TIE-LINE 637 WOOD-TO-STEEL PROJECT
MINOR PROJECT REFINEMENT
REQUEST FORM

Date Requested:	July 07, 2014	Report #:	013
Date Approved:	July 9, 2014	Approval Agency:	No other agency approval is required.
Property Owner(s):	Private and SDG&E Right-of-Way (ROW).	Location/Milepost:	SS-17, SS-17A, SS-17B and SS-18
Land Use/ Vegetative Cover:	The proposed impact area occurs within non-native grassland habitat and bare ground	Sensitive Resources:	Non-native grassland habitat within the understory of oak savannah habitat

Description of Refinement

Figure 1a: MPR Overview Map showing the original stringing site location (SS-17), adjacent pole locations, and the existing approved Project access roads (dashed red lines).

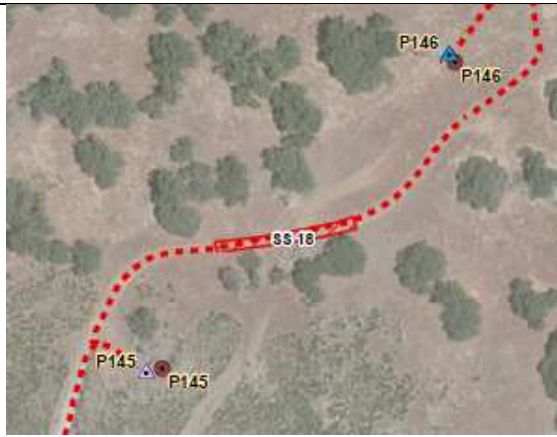
SS-17 and SS-18 were originally planned to be located within two discrete 14 foot by 150 foot areas located entirely within the existing approved project access road (refer to Figure 1a and 1b). SS-17A and SS-17B are new additional workspaces required for stringing activities that were not included as part of the Project as originally proposed.

The previously contemplated temporary workspace areas for SS-17 and SS-18 would have resulted in a total disturbance area of approximately 4,200 square feet (14 feet wide by 150 feet long for both locations) (refer to Figure 1a, 1b, 2 and 4).

Figure 3: Aerial image of proposed Stringing Site Nos. 17A and 17B, located between Structure Nos. P123 and P124.

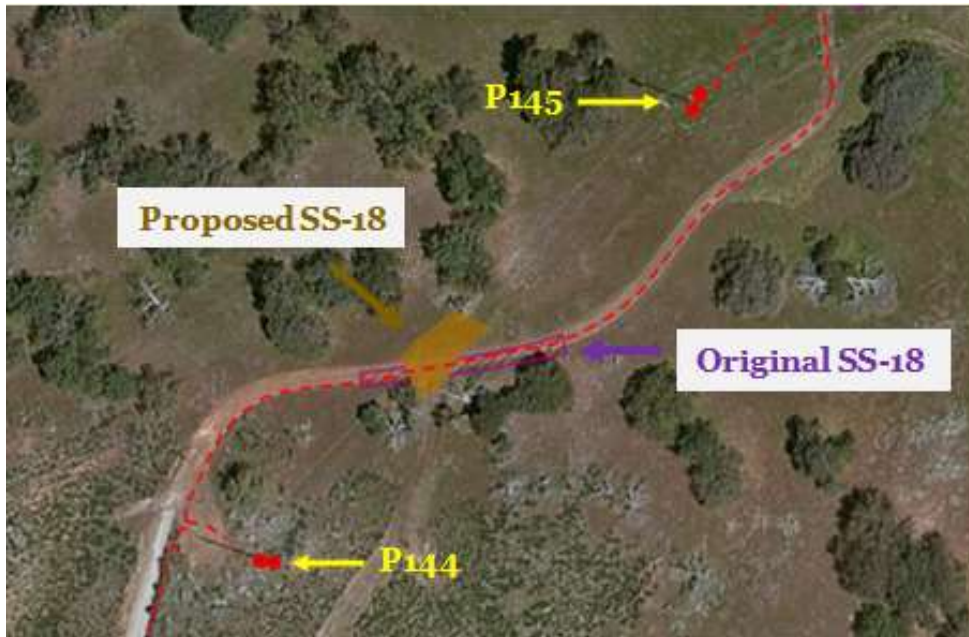
SDG&E proposes to use a different temporary workspace area for both SS-17 and SS-18, and utilize additional temporary workspace areas near SS-17 (SS-17A and SS-17B) in order to safely and successfully conduct stringing activities. The proposed refinement would shift SS-17 out of the existing main access road and adjacent to an approved secondary access road, as well as change the shape of the stringing site. The proposed refinement would shift SS-18 to partially transverse the main access road near the existing SS-18 location, as well as change the shape. Both the proposed SS-17 and SS-18 sites will replace the originally proposed locations. The proposed two additional temporary workspace areas required for stringing activities are located directly adjacent to the existing main access road northeast of Structure No. P123 (SS-17A and SS-17B). The proposed temporary workspace areas are further described below.

depicts the proposed new temporary workspace areas for SS-17A and SS-17B. Figure 4 depicts the proposed new temporary workspace area for SS-18, and the original SS-18 workspace. Photograph Nos. 1, 2 and 3 depict the proposed new temporary workspace area for SS-17, SS-17A and SS-17B, and SS-18, respectively.
